0.1 SAR REVISION STATUS

Title	SAFKEG-HS 3977A Docket No. 71-9338	Number	CTR 2008/11
		Issue	Revision <u>12</u>
		File Reference	[CTR2008-11-R12-Sc0]
Compiled		Checked	
	S Bryson		R A Vaughan
Approved		Date	<u>21 March 2017</u>
	R A Vaughan

Croft Associates Ltd F4 Culham Science Centre Abingdon Oxon OX14 3DB UK Tel 44 (0)1865 407740

Figure 3-8 Predicted Temperature of the Containment Vessel Lid Seal during the Fire Test with a 30 W source

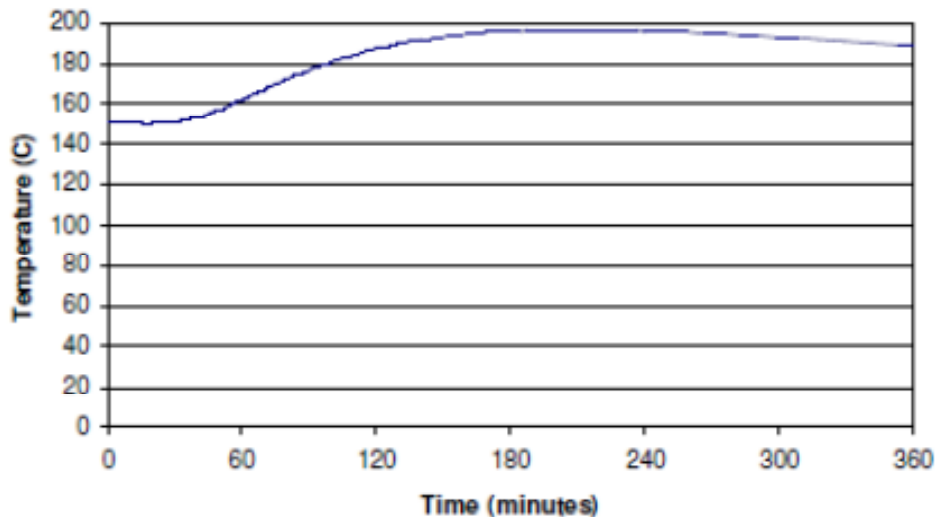
[Figure 3-8](#) shows the predicted temperature of the inner containment vessel seal during and after the thermal test. The lid seal reaches a maximum temperature of 192°C after 3 ½ hours. A similar maximum temperature is experienced by the depleted uranium shielding this temperature is well below its melting point of 1130°C.

Figure 1 - Insert No 3987 Seal Detail

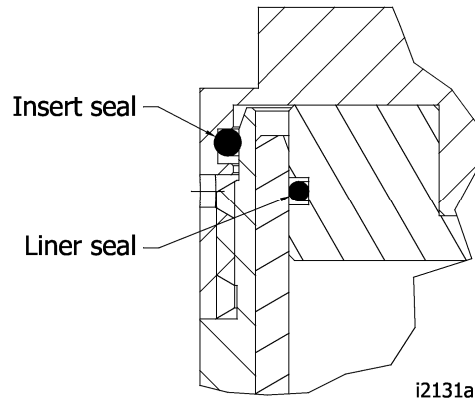
- 5) If I-131 is being shipped in insert 3987. Thoroughly inspect the PTFE liner, there shall be no stainless steel visible within the insert cavity, if any stainless steel is visible remove this insert from service. Check for any dust in the cavity and remove if present. Remove the insert seal shown in Figure 1. Close the insert and leak test the liner seal using the bubble method. The test sensitivity shall be 10^{-3} ref.cm³/s and the acceptance rate shall be no visible stream of bubbles. If the leak test fails remove the insert from service and raise an NCR. If the liner seal passes the bubble leak test insert a new insert seal.
